**Planning Commission
Staff Report**

September 11, 2013
Item 6.a.

SUBJECT: Work Session for P13-2078

PURPOSE: Work Session to review and receive comments on a Preliminary Review application to demolish the existing office building and construct 177 apartment units and related site improvements on a 5.9-acre site

Proposed Site Plan

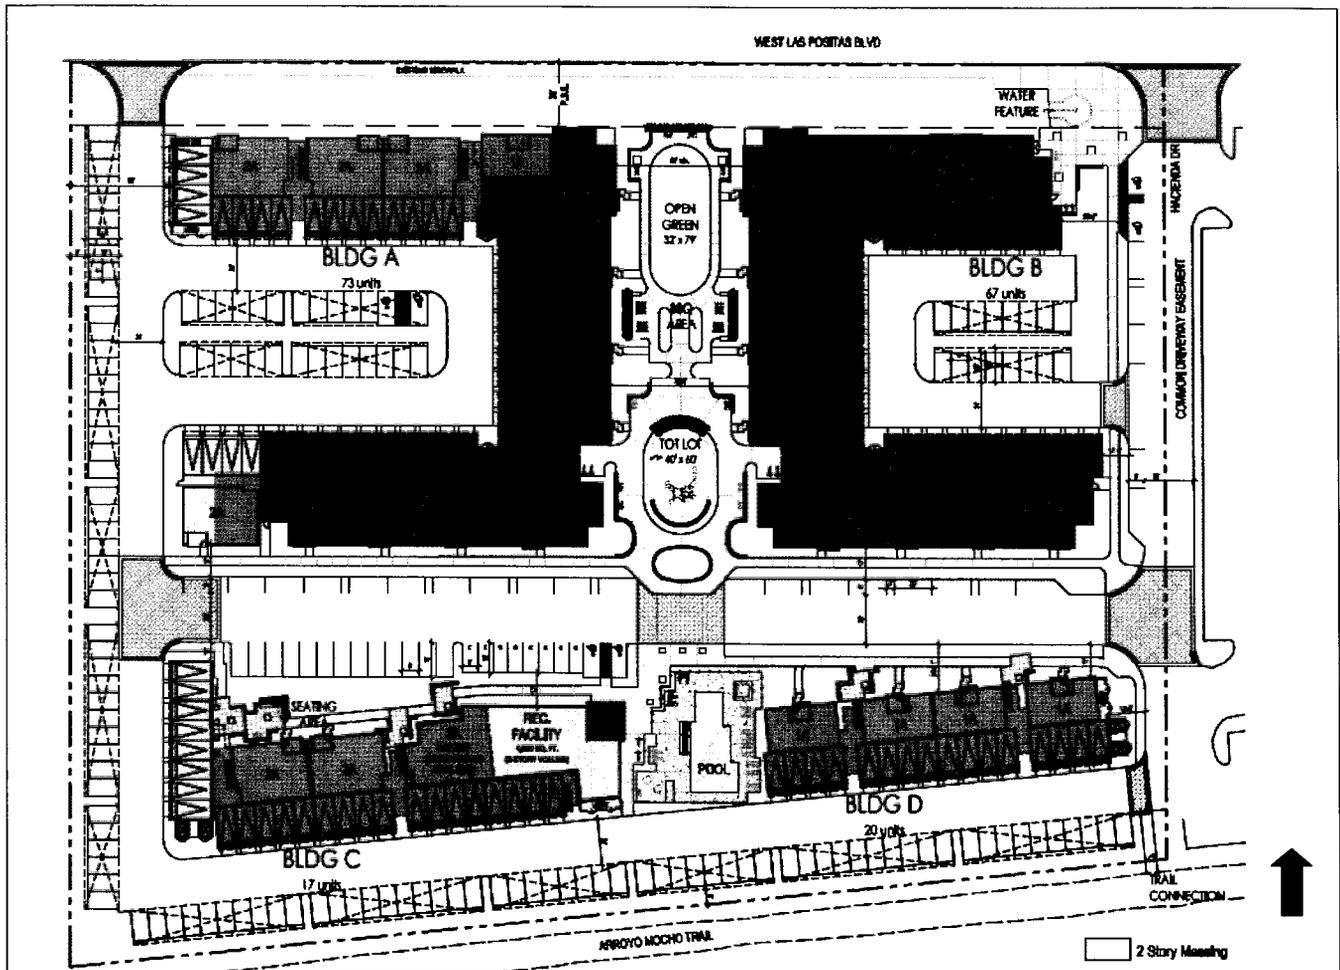
1. The carports would be located eight feet from the western property line. The applicant could remove carport parking along the western property line and still conform to the requirement of providing one covered parking space per residential unit. The applicant prefers to keep the carports. Staff suggested that the applicant discuss the proposed carport location with the adjacent property owners to the west to determine if they would object and/or request alternative mitigation.

2. The existing western entrance would serve as one of the two entrances to the proposed development. It should, like the eastern entrance, be designed as an internal street. Sheet A1.2 shows it is designed as an alley.

Site Plan. As proposed, the buildings meet the setback requirements. The site plan shows a feathering of densities with the lowest densities by the Arroyo Mocho and adjacent one-story commercial development and that stories above the second story on the west elevation are stepped back. The project's main entrance would be from the eastern edge of the site at the existing signalized intersection at West 0Las Positas Boulevard and Hacienda Drive. The applicant will provide building entries for Buildings A and B that face West Las Positas Boulevard to meet the Design Guidelines requirements. Staff believes that a pedestrian connection needs to be provided between West Las Positas Boulevard to the proposed open space area.

Special Design Standards and Guidelines, page 55: No structure (not including light fixtures) shall be located within 50 feet of the western property line.

Development Standards, page 13, requires a distinct hierarchy of circulation including public streets, internal streets, alleys, etc. Section A1.b states that alleys should not be used for primary circulation.

Conceptual Building Elevations on West Las Positas Boulevard

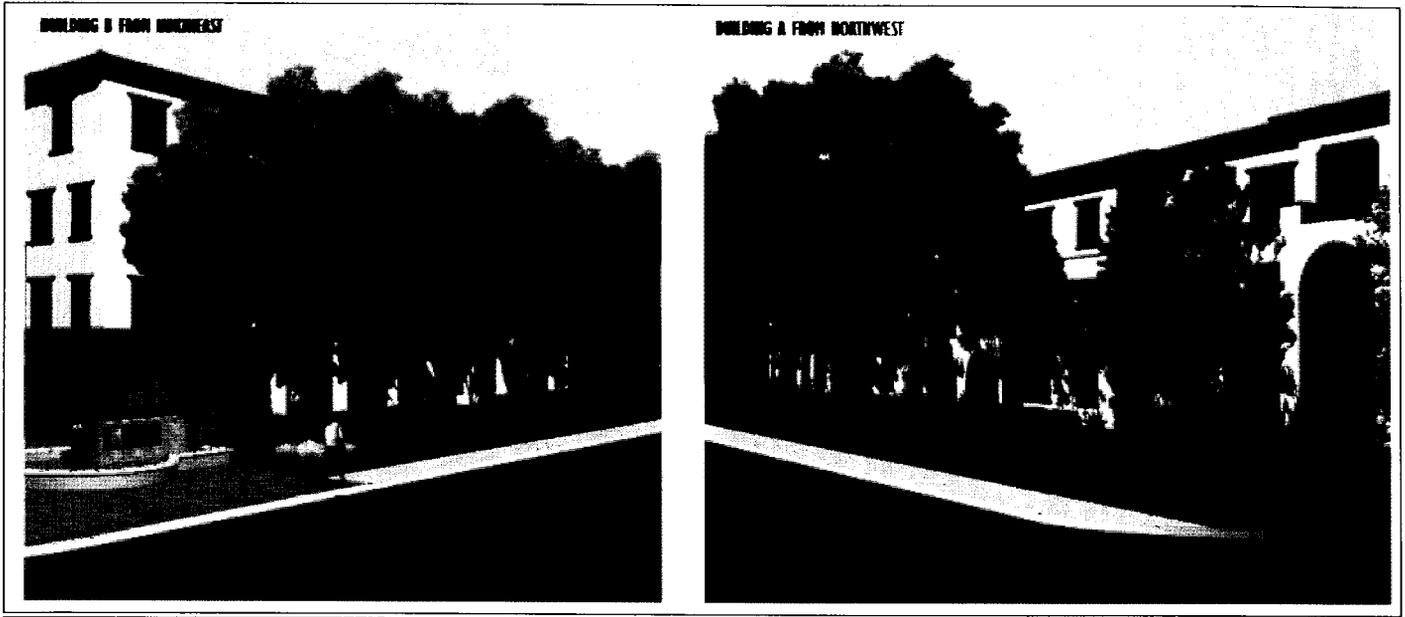
Building Design. Given the high visibility of the site directly on a major thoroughfare, staff feels that the buildings will need to be designed with a high quality visual image. Staff believes that the proposed buildings are generally well designed. Staff has made the following suggestions to the applicant:

- Provide additional details such as exposed rafter tails, window planter boxes, wrought-iron detailing, etc.
- Modify and enhance the individual unit entries on the ground level so that they would be a prominent feature of the building.
- "Punched in" the windows from the exterior building wall.
- Provide an enhanced stucco finish such as Santa Barbara finish (Santa Barbara finish is a smooth, stucco finish with minor relief textures and a subtle, variegated color.)
